GLOBUS NIGHT STAND — STAND-IN REDLINE v4

RFQ 20261109-164445-3593d492 · QTY 2 · 22" W x 20" D x 22" H · whitewashed maple · antique bronze legs · inches · scale 1:7.6

REV 4 — 2026-11-09 — lower front changed to one full-width drawer per client; sheet color-coded verified vs. assumption

FRONT ELEVATION (1:7.6)

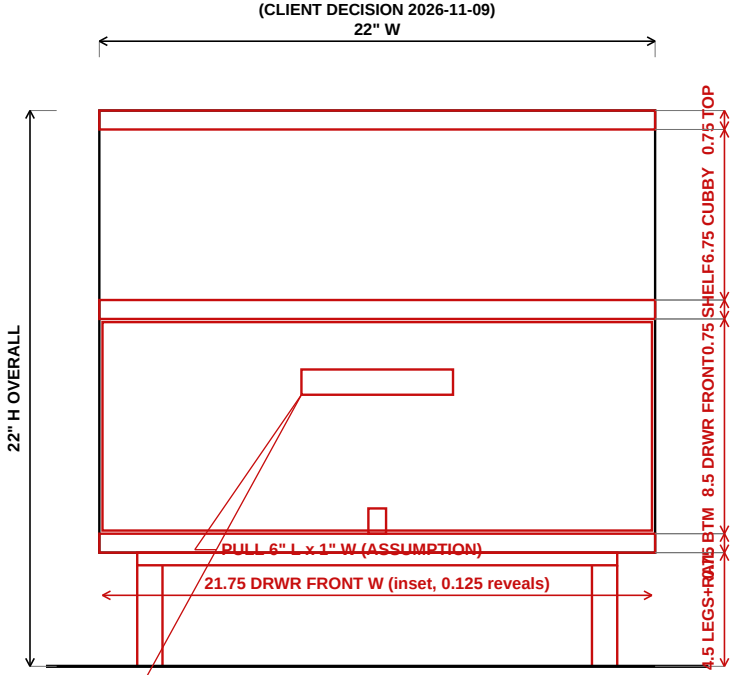
full-width drawer below shelf · cubby above · cubby OPEN THROUGH BACK (CLIENT DECISION 2026-11-09)

SIDE ELEVATION (1:7.6)

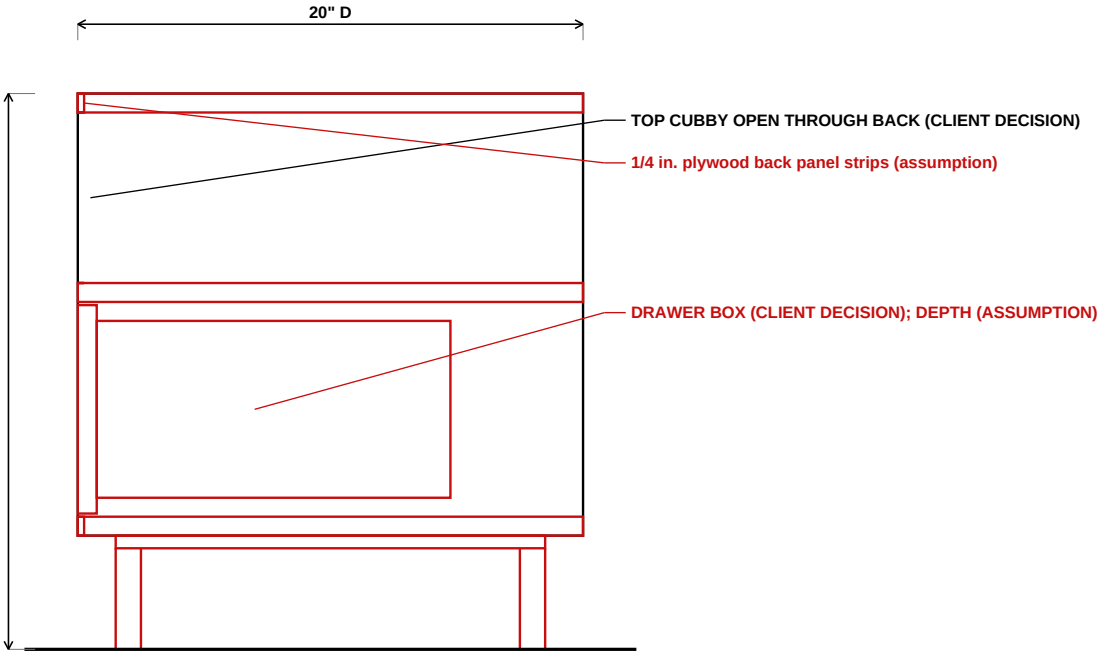
cubby open through back · drawer below (CLIENT DECISION 2026-11-09)

FABRICATED STRAP PULL, CENTERED (CLIENT DECISION; SIZE ASSUMPTION)
